REMARKS/ARGUMENTS

Claims 7-12 are pending. Claims 7-12 have been rejected. Claims 7-8 and 10-12 have been amended. Reconsideration is respectfully requested.

APPENDIX

FIG. 4

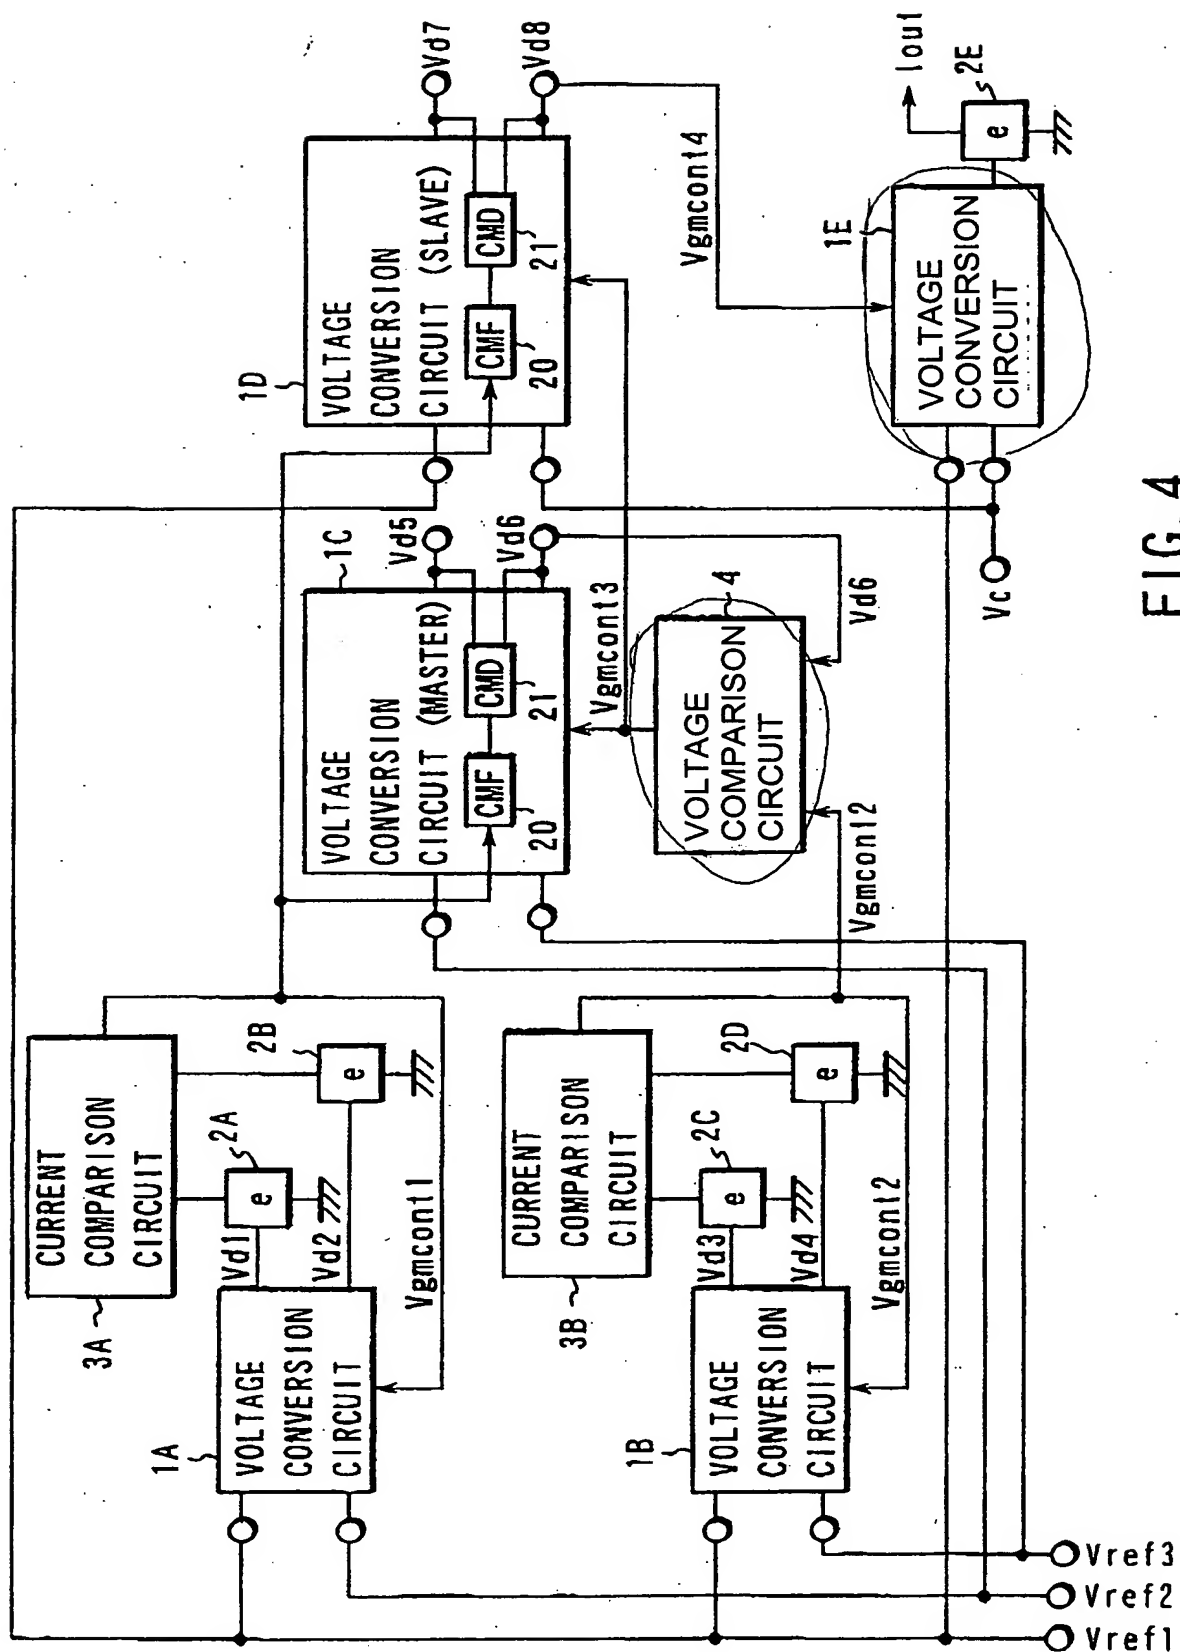
The drawings have been objected to because of minor informalities in the drawings. Figure 4 has been amended to change the block corresponding to reference numeral 4 to read – voltage comparison circuit – and the block corresponding to reference numeral 1E to read – voltage conversion circuit –. No new matter has been added. Approval of the drawing change is requested. Withdrawal of the objection is respectfully requested.
